PLANNING ISSUE

CLIENT		
MR AND MRS MARSHALL		
PROJECT		
BRAE-MAR, HARTLEY, KENT, DA3 8ER		
PROPOSED DRIVEWAY WALL AND ENTRY GATE		
DRAWING		
GENERAL ARRANGEMENT		
PROP. WALL & ENTRY GATE ELEVATION & PLAN		
SCALE @ A3	DRAWN	CHECKED
1:50 @	VG	LN
CREATION DATE	REVISION	
MARCH 2021	B	
KLEDESIGN DRAWING NO.		
K1147 - KLE - DA3 - 00 - DR - A - 025		
PROJECT NO - COMPANY - ZONE - LEVEL - TYPE - ROLE - NUMBER		
<small>© COPYRIGHT. ALL RIGHTS RESERVED. - THIS DRAWING MUST NOT BE REPRODUCED WITHOUT PERMISSION. - THIS DRAWING MUST BE READ IN CONJUNCTION WITH ALL RELEVANT CONSULTANT / SPECIALIST DRAWINGS / INFORMATION. - THIS DRAWING MUST NOT BE USED FOR CONSTRUCTION UNLESS ISSUED FOR CONSTRUCTION. - ALL DIMENSIONS ON THIS DRAWING ARE IN MILLIMETERS (UNLESS OTHERWISE STATED). - ANY DISCREPANCIES MUST BE REPORTED TO KLEDESIGN IMMEDIATELY. - DO NOT SCALE OFF DRAWINGS. USE DISPLAYED DIMENSIONS ONLY.</small>

1 PROPOSED DRIVEWAY GATE AND WALL - ELEV A
1:50 @ A3

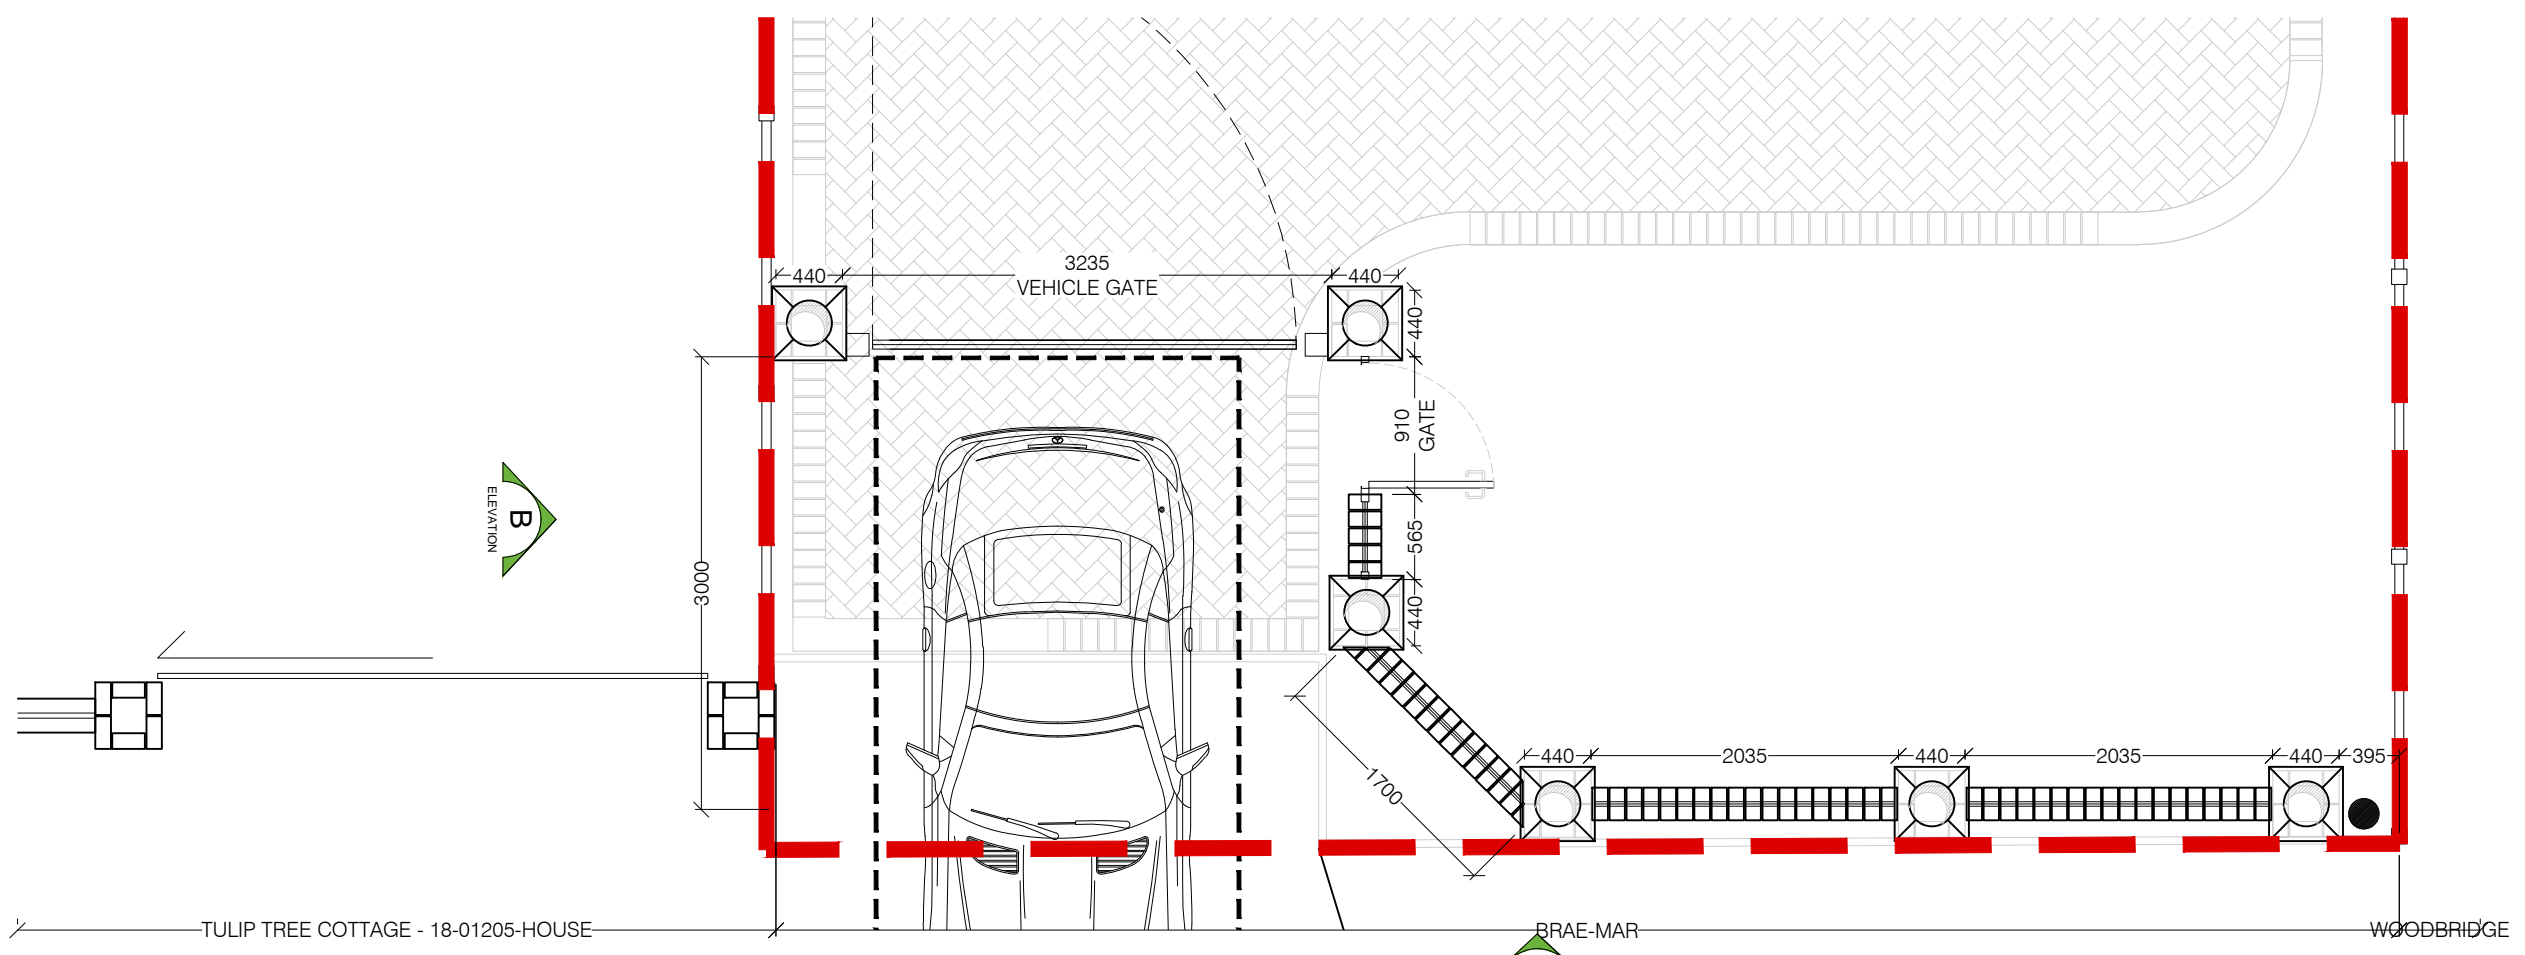
REV	DATE	DESCRIPTION	DR	CH
B	10.10.21	MINOR AMENDMENT - Proposed Railings altered to a straight top rail in lieu of previously approved curved top rail. Top of gate shape slightly different, now a single curve rather than the triple sweep style of the previously approved design. Revised drawing issued to LA.	VG	LN
A	13.04.21	PLANNING VALIDATION - Pedestrian Gate Elevation added to drawing as requested by Sevenoaks Council	VG	LN
-	31.03.21	PLANNING APPLICATION MADE - Following receipt of client approval.	VG	LN
